KIND		TITLE		CUSTOMER			
MMC8		MINI-MINI CHUCK ADVANCED ALPHA					
MACHINE MODEL		CODE NO.		DESIGNED	CHECKED	APPROVED	
		NCAT40-MMC8C-90U-AA-IDU		S. CHIKAMURA			
SCALE	1:1	NIKKEN KOSAKUSHO WORKS, LTD.		DIR-NAME		MMA1	
DATE	2024. 04. 18			DRWG NO.		MMA03-47008/1

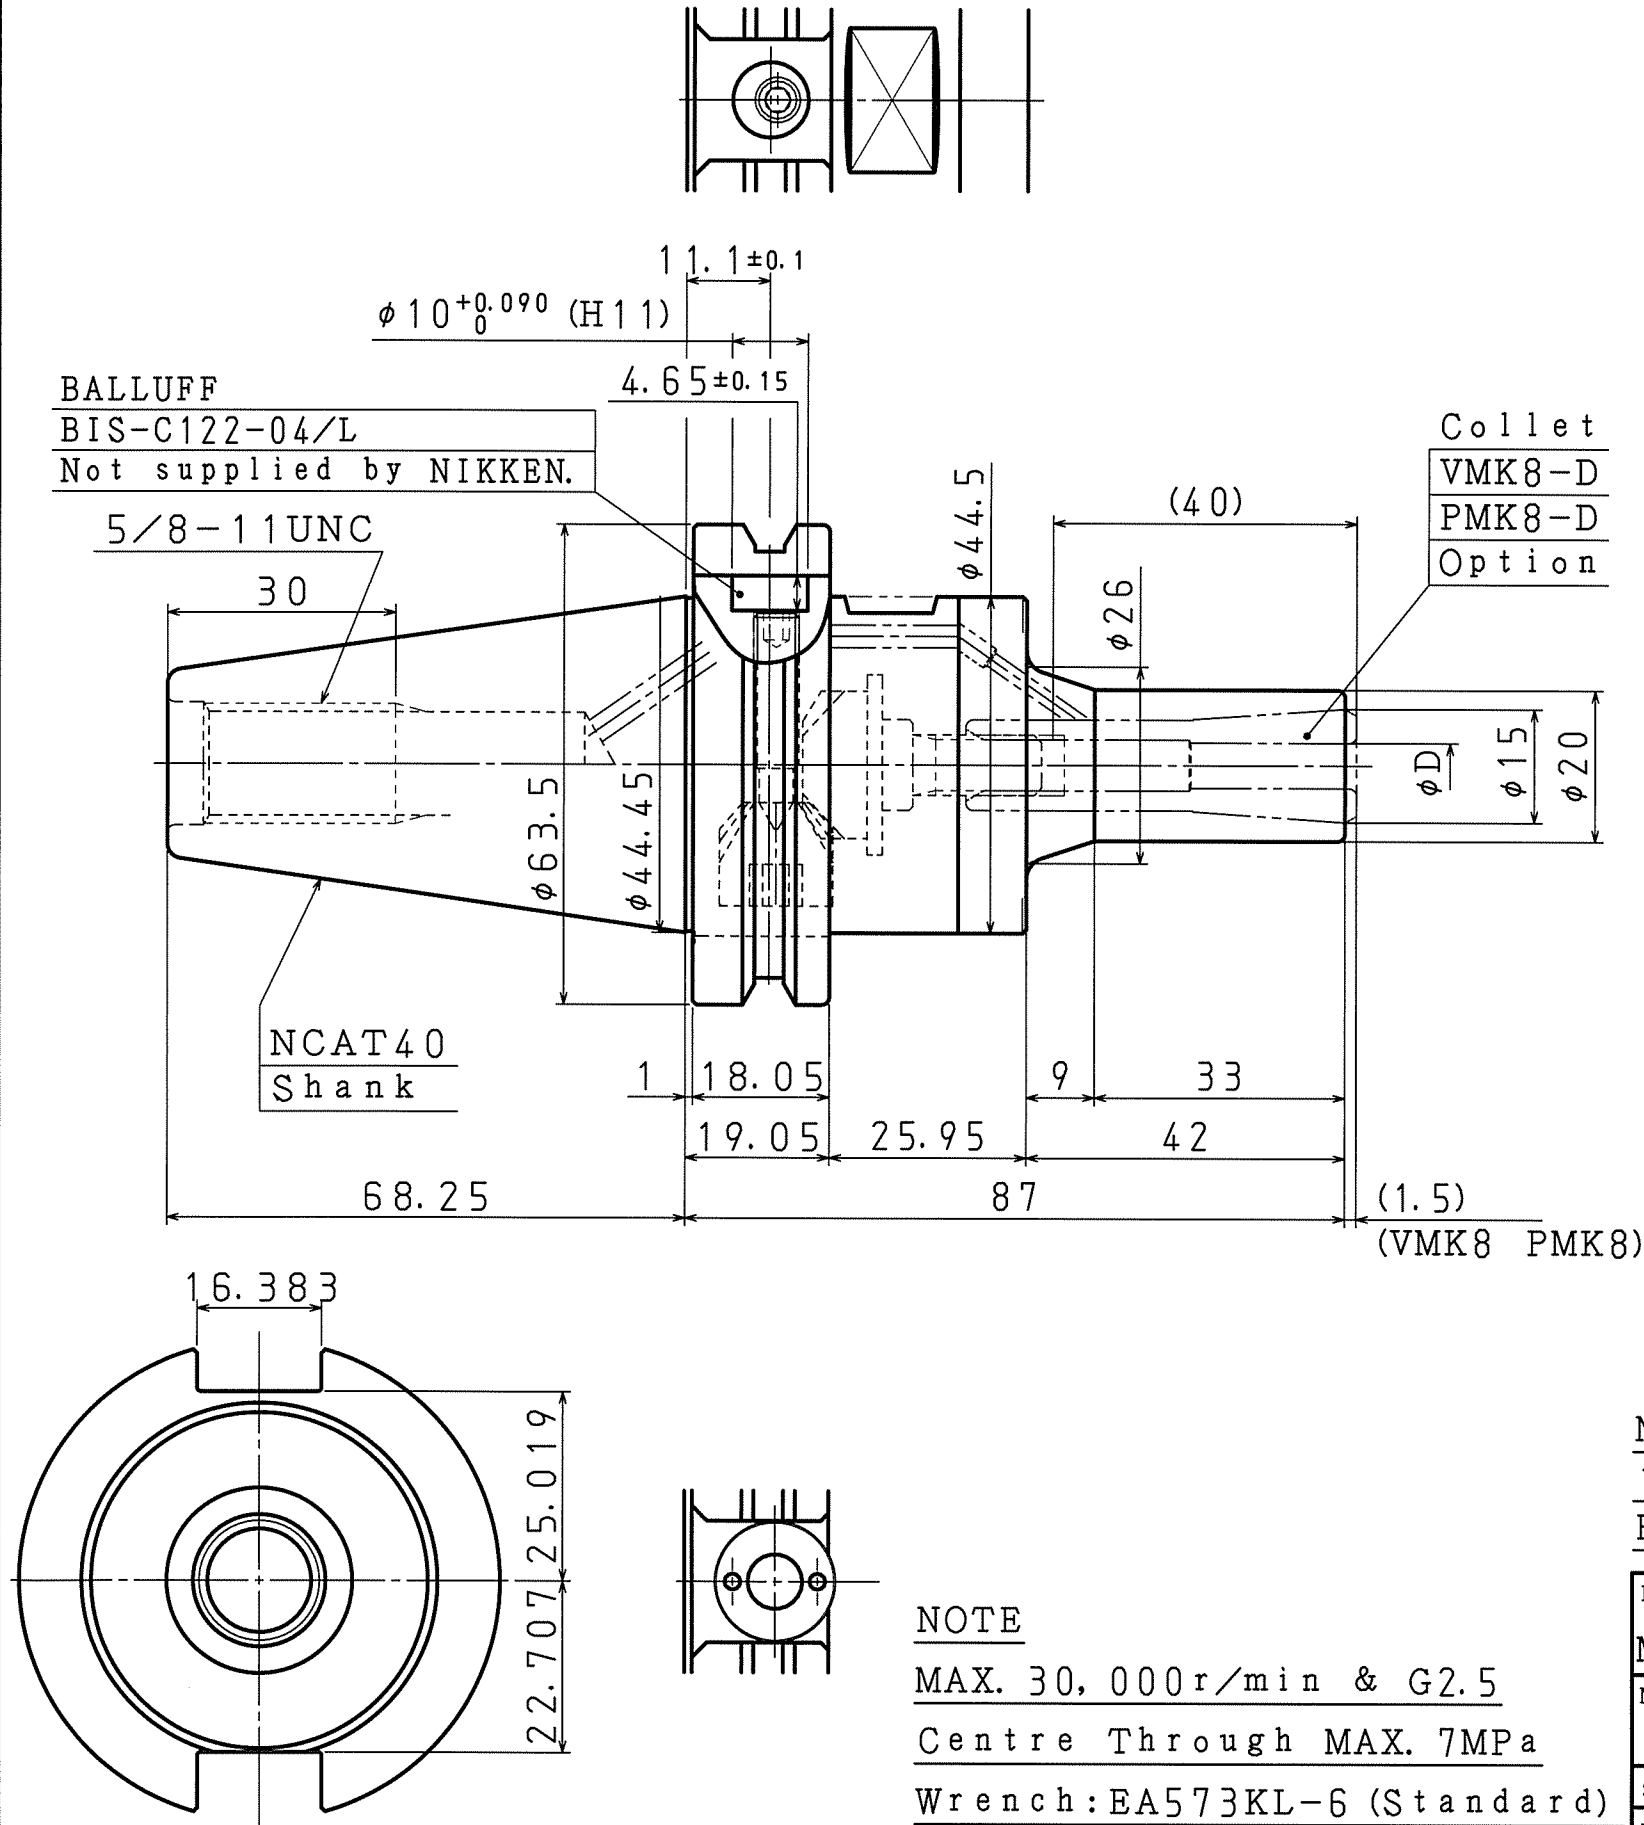
1995 Collet protrusion changed from 3 mm to 1.5 mm

Effective GL: 88.5mm
